Subdivision Authority

File No. LDA10-0384

RE: Tentative plan of subdivision to create 30 single detached residential lots from portions of SE and SW 19-53-25-4, located west of 199 Street; **BIG LAKE NEIGHBOURHOOD ONE**

SUBDIVISION CONDITIONS OF APPROVAL MAP

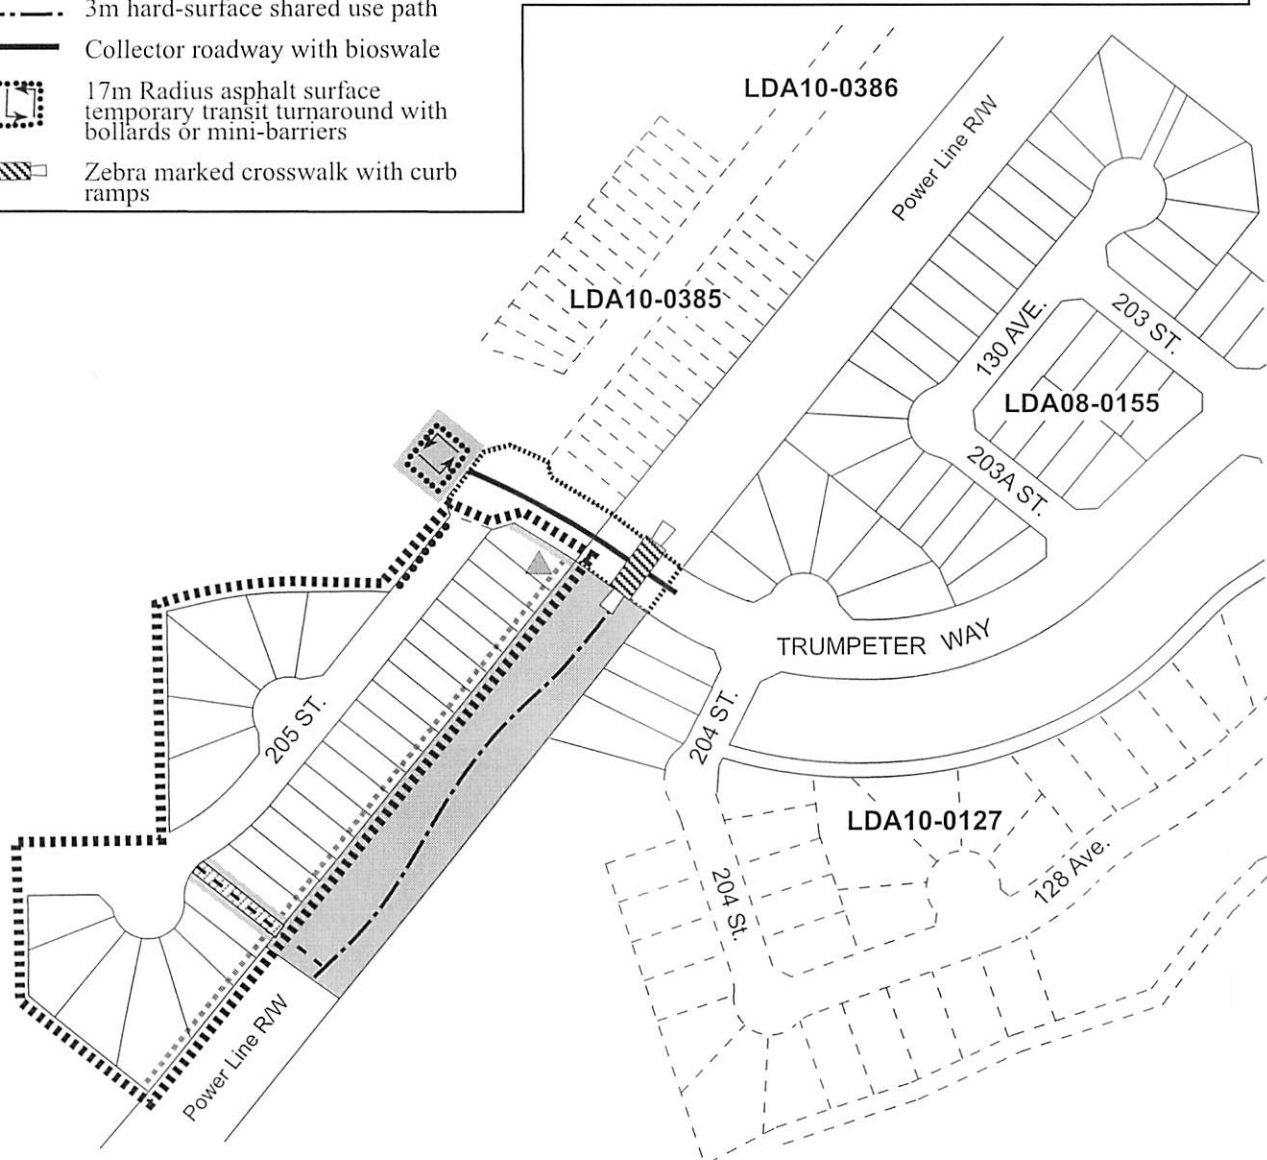
4. that the subdivision boundary be amended to include the extension of Trumpeter Way, as shown on the "Conditions of Approval" map, Enclosure I;
5. that the owner register the walkway as legal road-right-of-way, as shown on the Conditions of Approval" map, Enclosure I; and

10. that the Engineering Drawings include an offset 17 m radius asphalt surface temporary transit turn around with bollards or mini-barriers, as shown on the "Conditions of Approval" map, Enclosure I. The turnaround will be required to be gravel prior to CCC and asphalt prior to FAC or at the discretion and direction of the Transportation Department as shown on the "Conditions of Approval" map, Enclosure I;

11. that the owner construct a 3 m hard-surface shared use path within the power line right-of-way, from Trumpeter Way to south of the walkway, with a dividing yellow centreline and "Shared Use" signage, lighting, bollards and landscaping as shown on the "Conditions of Approval" map, Enclosure I;

12. that the owner provide a zebra marked crosswalk with curb ramps and pedestrian signage at the mid-block crossing, as shown on the "Conditions of Approval" map, Enclosure I;

13. that the owner construct a 1.5 m concrete walkway with bollards, lighting and minimum 1.8 m uniform fencing to be provided within the residential property lines, as shown on the "Conditions of Approval" map, Enclosure I;

14. that the owner construct all fences positioned wholly on privately owned land as shown on the "Conditions of Approval" map, Enclosure I;

15. that the owner submit a driveway plan for the lot adjacent to Trumpeter Way to ensure that the driveway does not encroach into any portion of the corner radius of the curve, as shown on the "Conditions of Approval" map, Enclosure I; and
16. that the owner is responsible for the design, landscaping and construction within the public utility lots, utility right-of-way, road islands, boulevards, medians, walkways and Municipal Reserve parcels, to the satisfaction of the Community Services, Transportation and Asset Management and Public Works Departments.
